TITLE: CA 18 DISPLAY			
DRAWN:	DATED:	CODE:	SIZE:
CHECKED: C.MAHONEY	DATED: 9/29/98	DRAWING NO: 4301-00.SCH	REV: 00
QUALITY CONTROL:	DATED:	SCALE:	
RELEASED:	DATED:	SHEET: 1 OF 1

COMPANY:			
CREST AUDIO INC. 100 EISENHOWER DR. PARAMUS NJ			
TITLE:			
CA18 FAN DRIVER PC BOARD			
21A3101-00			
CODE:	SIZE:	DRAWING NO:	REV:
	B	3101-00.SCH	00
SCALE:			SHEET: 1 OF 2

CRESTAUDIO	
TITLE: CA18 PREAMP PC BOARD 21D3080-00	
3080-00.SCH	02
SHEET 1 OF 2

TITLE: CA18 OUTPUT MODULE

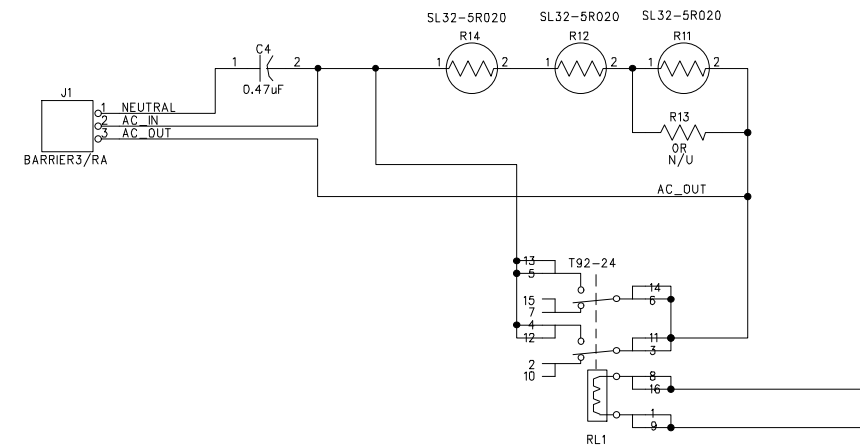
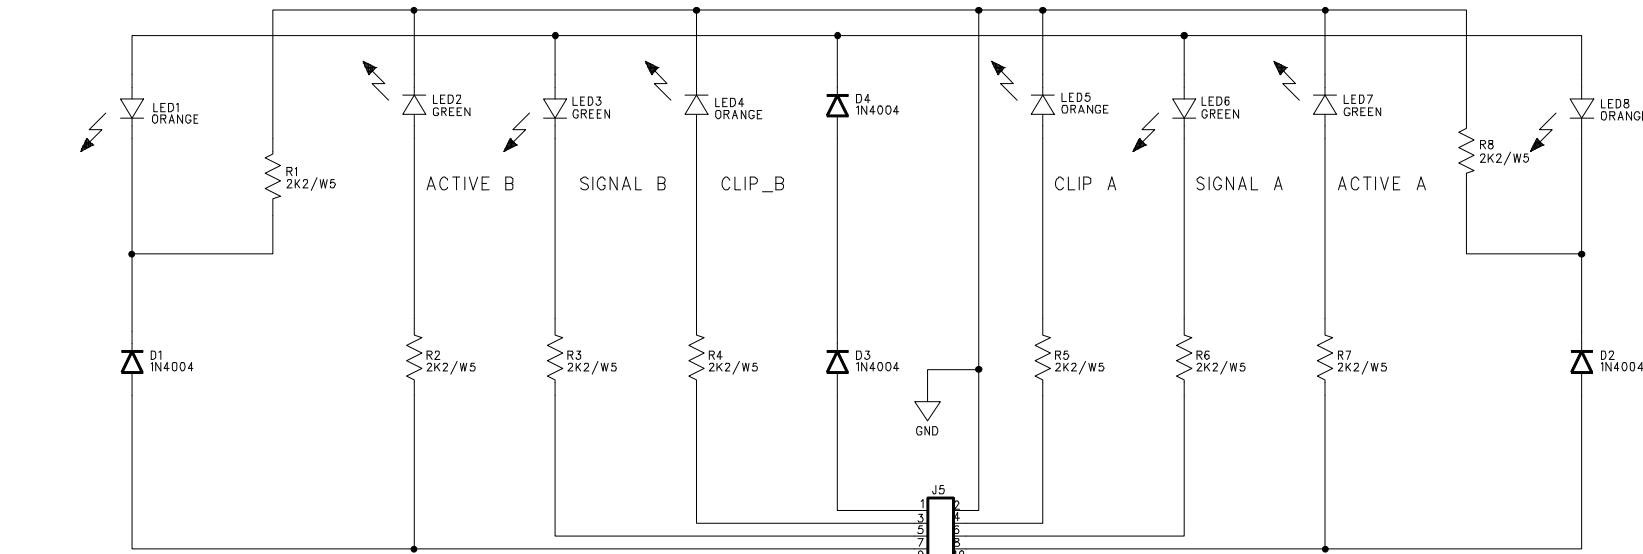
REV 1 (SCHEMATIC CHANGES)
 1) PINOUT OF J1 CHANGED TO REFLECT NEW PCB LAYOUT BECAUSE OF LARGER TRANSF.
 2) J7 & J8 CHANGED TO GOLD RIGHT ANGLE HEADER FROM STRAIGHT PIN HEADER. NEW CONNECTOR 26-61-5030.
 3) J2 CHANGED TO KEY8190 FROM A BARRIER.
 4) NEW PCB # 26D3254-02.

NEW PCB 26C4301-00 FOR CA 18 DISPLAY
 26D3254-03 BOARDS ARE INCORRECT
 NEW CREST P/N & DRAWING NUMBER WAS ISSUED

NOTE:
 ADDITIONAL INRUSH LIMITER ADDED, 9/29/98

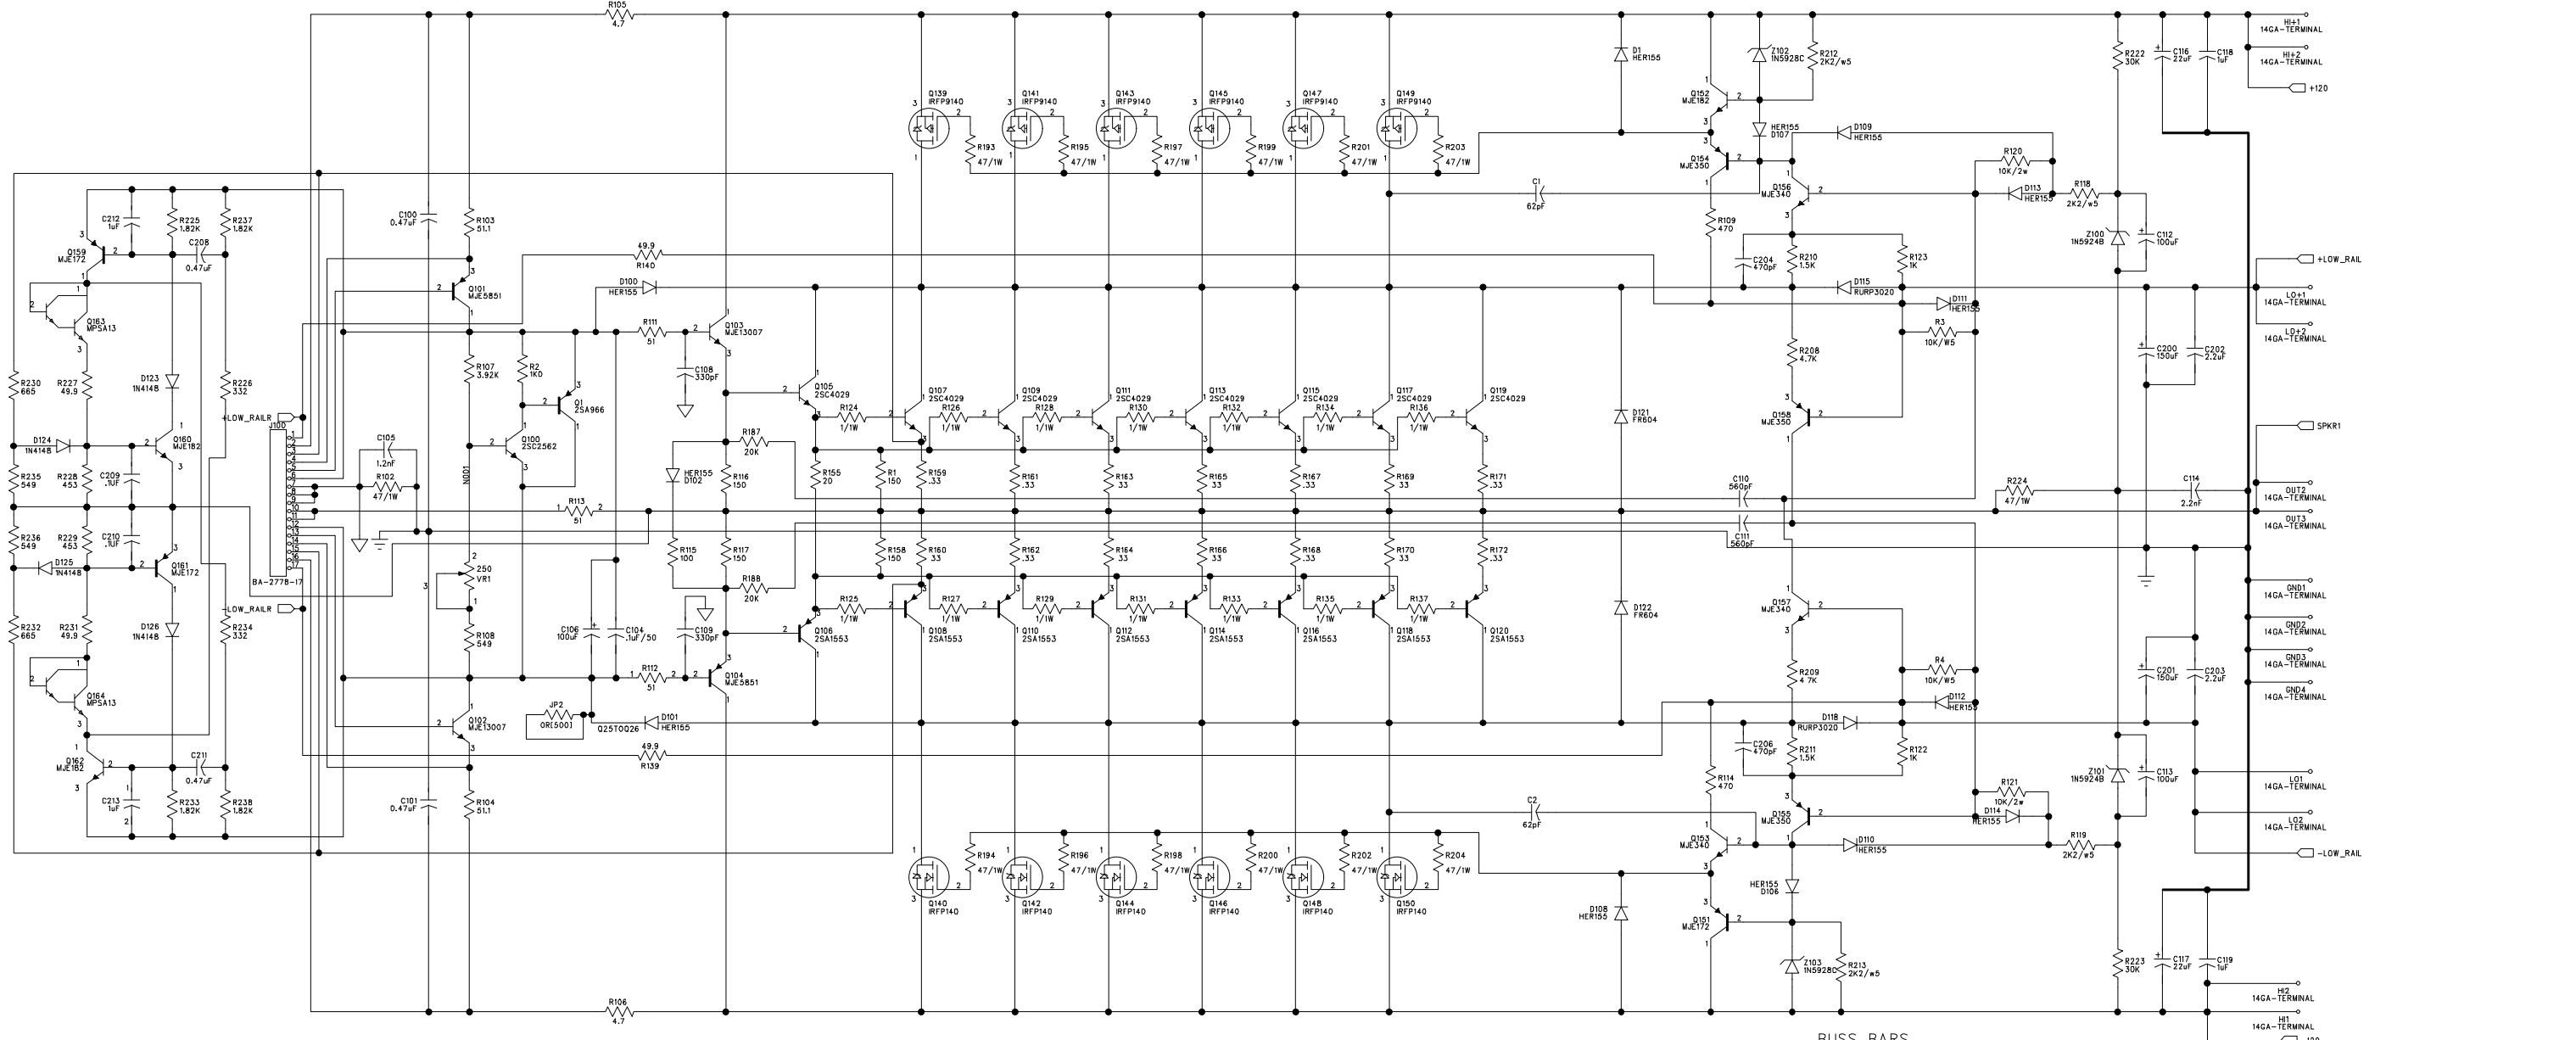
REVISION RECORD			
LTR	ECO NO:	APPROVED:	DATE:
	#3104 R230, 232 WERE 549H
